STATE OF CONNECTICUT  
CONNECTICUT SITING COUNCIL

IN RE: :  
: :  
APPLICATION OF CELLCO PARTNERSHIP : DOCKET NO. 481  
D/B/A VERIZON WIRELESS FOR A :  
CERTIFICATE OF ENVIRONMENTAL :  
COMPATIBILITY AND PUBLIC NEED FOR :  
THE CONSTRUCTION, MAINTENANCE AND :  
OPERATION OF A WIRELESS :  
TELECOMMUNICATIONS FACILITY AT 667, :  
665, 663 AND 663R MAIN STREET IN :  
CROMWELL, CONNECTICUT : APRIL 12, 2018

**RESPONSES OF CELLCO PARTNERSHIP D/B/A VERIZON WIRELESS  
TO CONNECTICUT SITING COUNCIL PRE-HEARING INTERROGATORIES**

ABUTTERS MAP

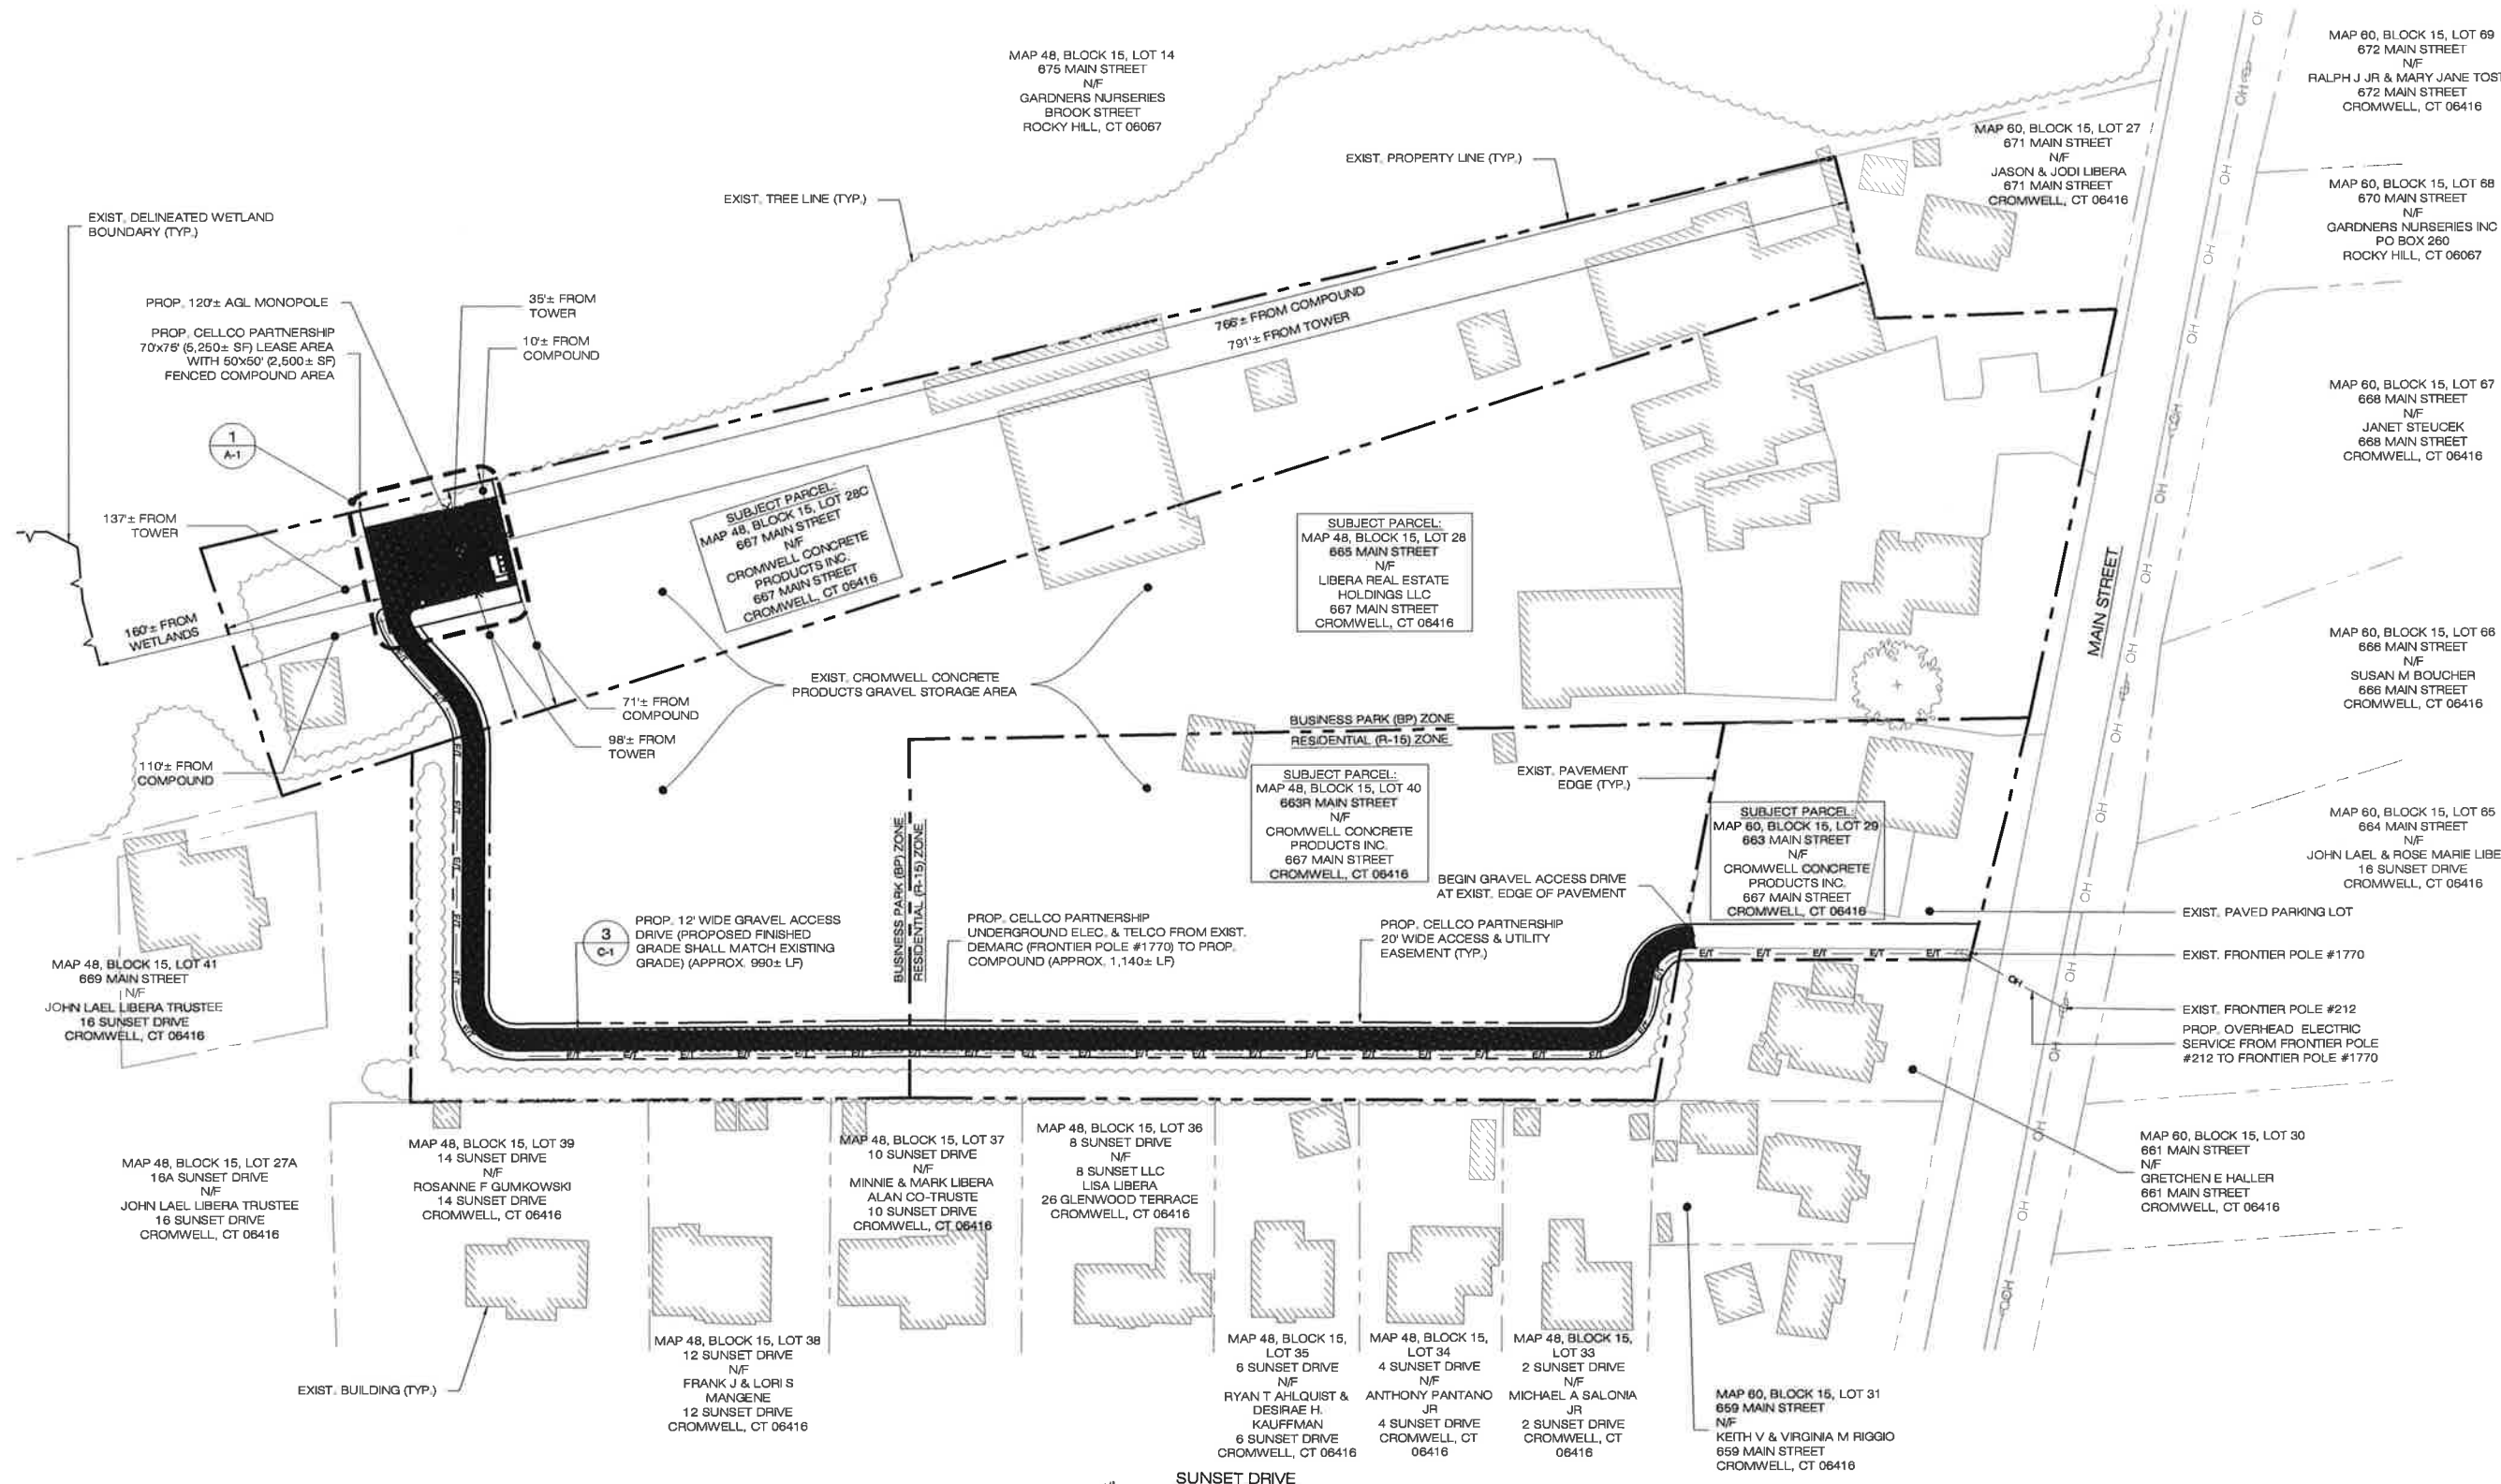
Referencing Sheet R-1 of Cellco Partnership d/b/a Verizon Wireless' (Cellco) Application, the proposed facility would be located in the northwestern corner of the 667 Main Street property. Given the area of the subject properties on 667, 665, 663 and 663R Main Street, how was the proposed tower location selected?

On March 7, 2018, Counsel for Cellco was contacted by Attorney Keith Ainsworth, representing John Lael Libera, the owner of the property at 16 Sunset Drive, the closest abutting residence to the tower site. Mr. Ainsworth asked, on behalf of his client, if Cellco would

consider moving the tower site 100 feet to the east of its proposed location. Cellco reached out to its landlord who was agreeable to the proposed relocation of the tower site. Included in Attachment 1 to these responses is a revised set of project plans showing the alternative tower location that has been proposed to accommodate Mr. Libera's request.

The primary reason for selecting the northwest corner of the subject parcel was to limit, to the extent possible, impacting the landlords existing business operations at the site. As shown on the Site Schematic (Aerial Photo) included behind Tab 1, Page 3 of the Application, much of the 7.78 acre Cromwell Concrete Products parcel (the "Property") is occupied by buildings or used for products and materials storage. The northwest portion of the property is also further from residences along Sunset Drive and Main Street.

**Site Search Summary Map**

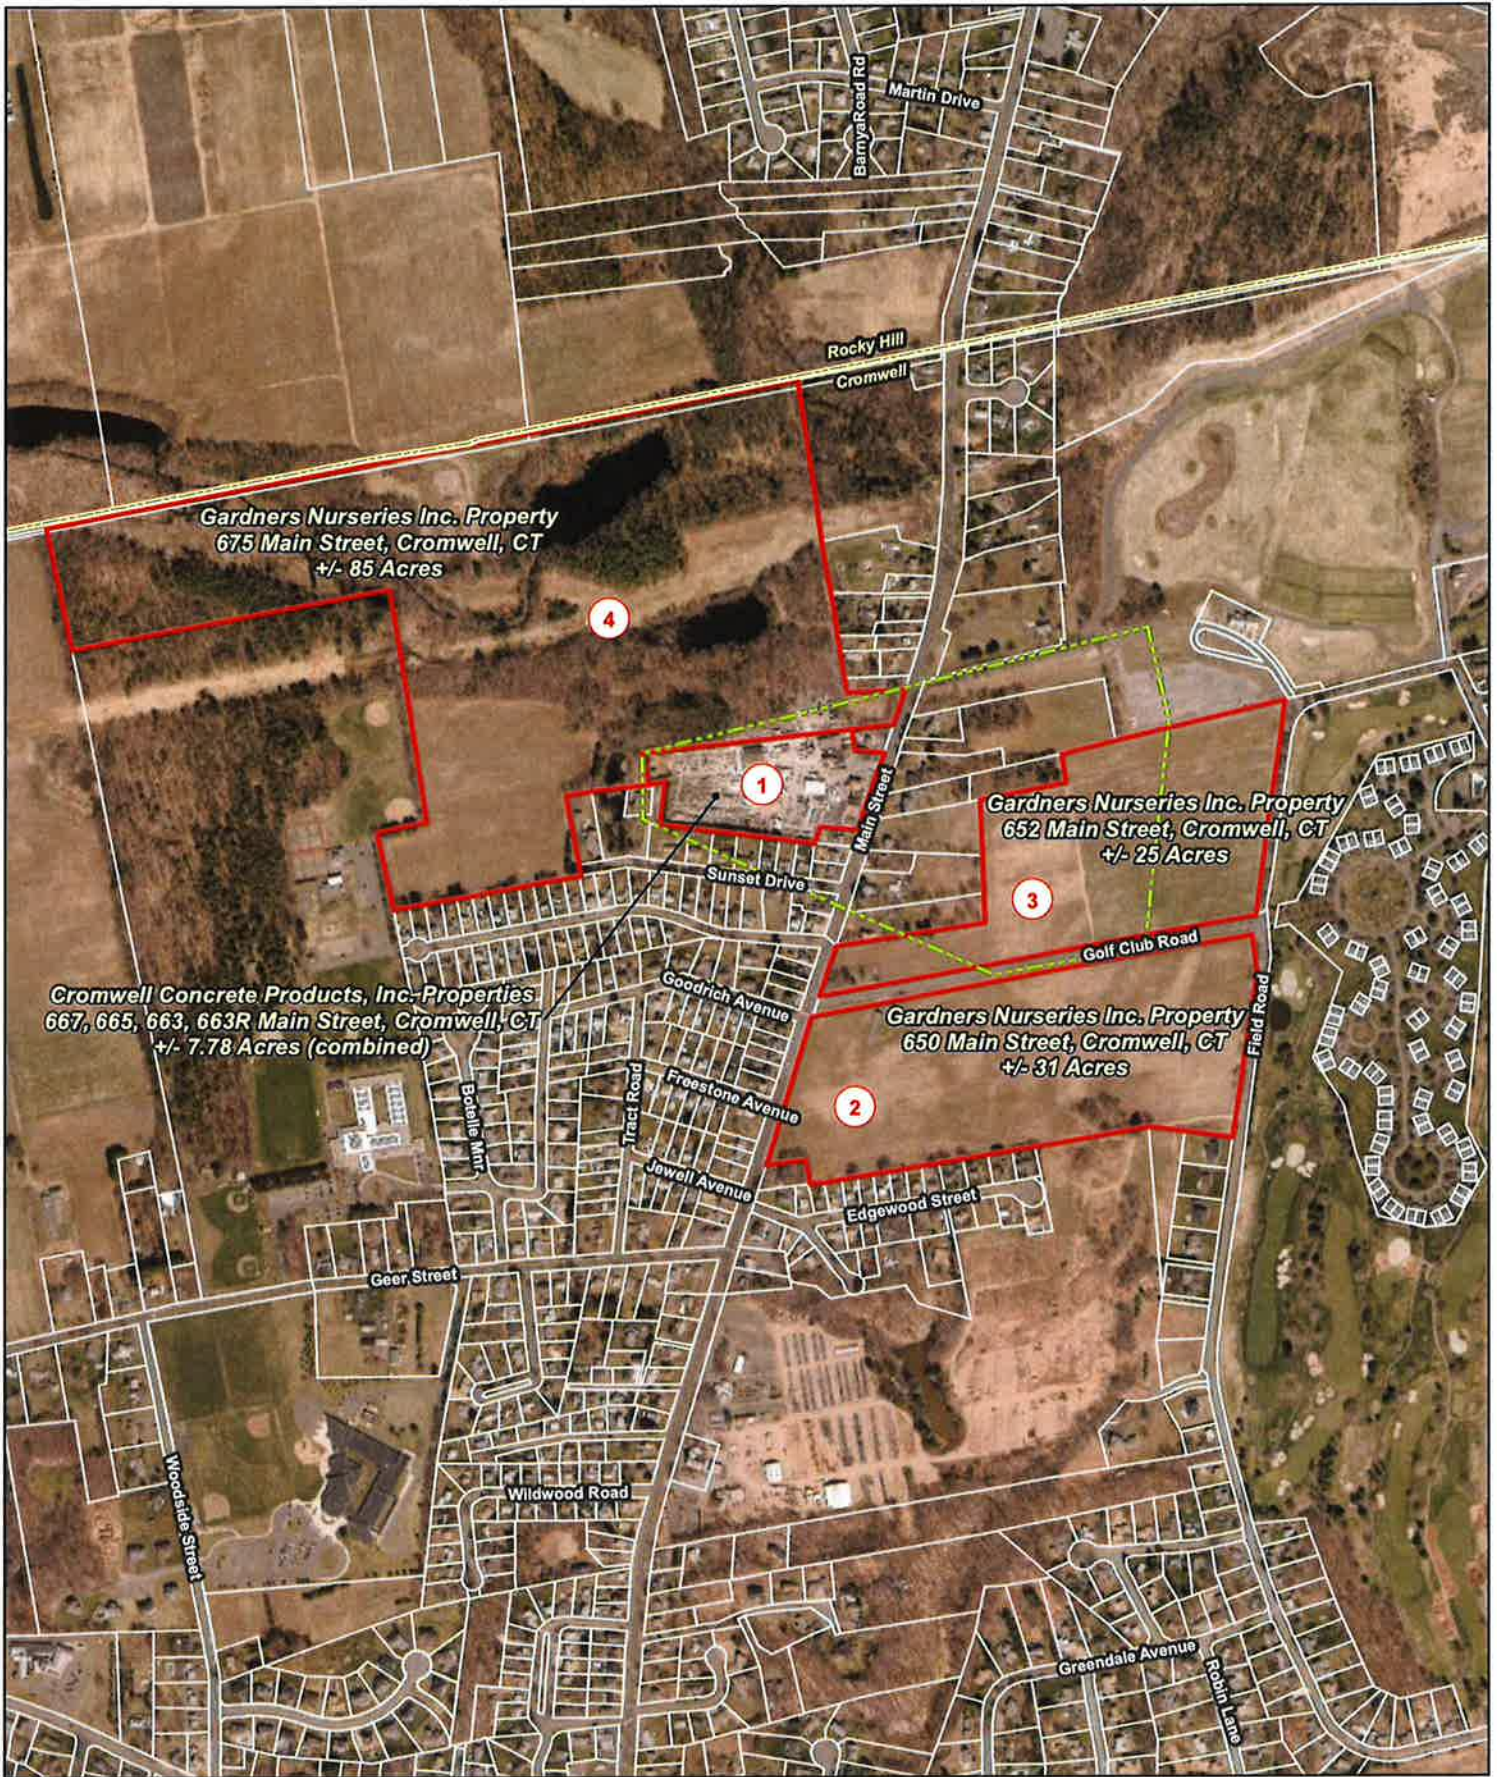
Referencing Tab 8 of the Application, when was the search ring first established for this area? What was the approximate radius of Cellco's search ring for this area? Provide the approximate longitude and latitude coordinates of the center of the search ring for this area. Provide a site search summary map with the search ring.

The Cromwell North 2 Facility search area was established in September of 2014. The search area contains approximately 0.072 square miles and is centered, roughly, on the residential parcel at 664 Main Street (Coordinates are 41.631874 /72.649987). The site search summary map requested is included in Attachment 2 to these responses.
